Lower Byrom Street Gateway / HVM, Science and Industry Museum, Liverpool Road, Manchester, M3 4FP – Application for a Section 19 (variation) attached to Listed Building Consent Application Ref: 143390/LO/2025 & 143391/LO/2025

This application seeks a Section 19 variation to Condition 3.

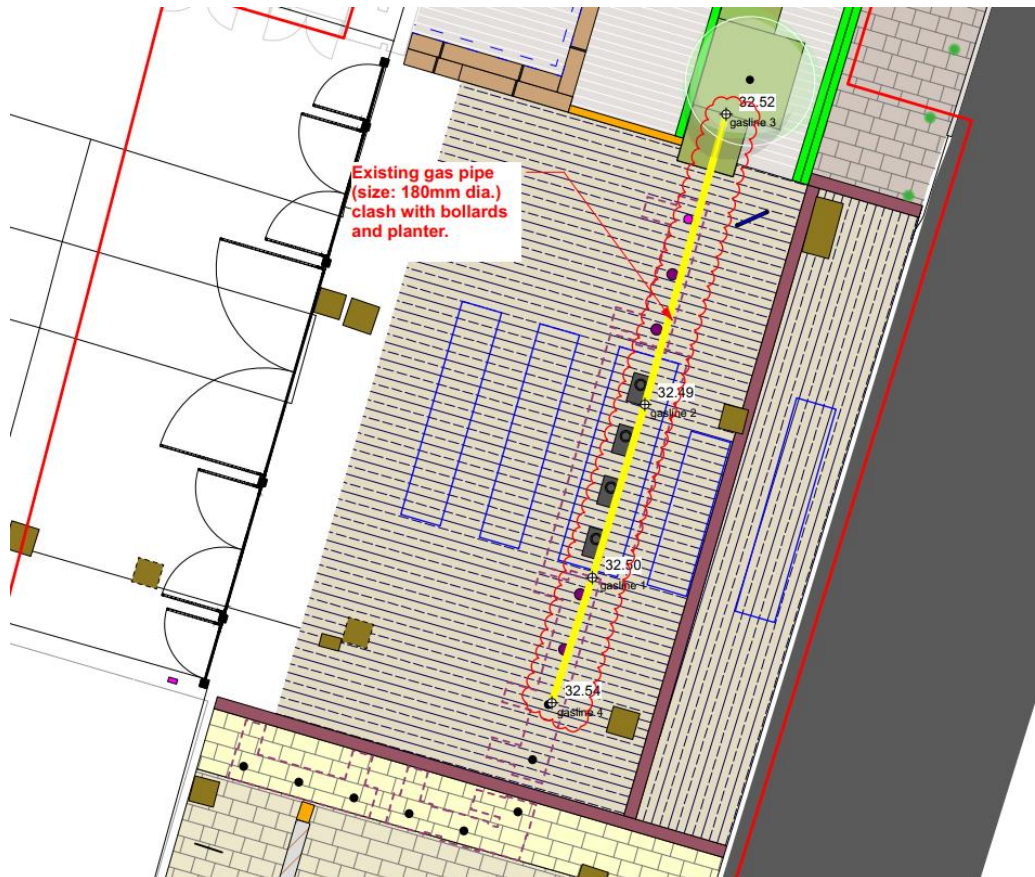
During the course of the onsite works, the contractor discovered an existing gas main running through the location of the originally proposed PAS-rated automatic bollards.

The plan extract below shows the gas main position (yellow line) and consented bollard positions.

This was not indicated on the utilities survey drawings and therefore the issue was unforeseen. To resolve the clash, the main arrangement of proposed bollard in front of the entrance gates have been revised and moved by approximately 1200mm. One no. of bollards was removed. Confirmation of the gas main easement has been obtained from Cadent, which confirms that a minimum clearance of 300 mm is required to the foundation of the bollards. The revised arrangement maintains a minimum separation of 300 mm between the bollard foundations and the gas main, ensuring compliance with these easement requirements.

This move had a minimal knock-on effect on the planter positions and the bollard row between the planters, which were also moved west by approximately 300mm. The planters were spaced a bit further apart to achieve a spacing that meets PAS rating compliance. As a consequence of the revised layout, the extent of the secure area has been reduced; however, this reduction is not considered significant.
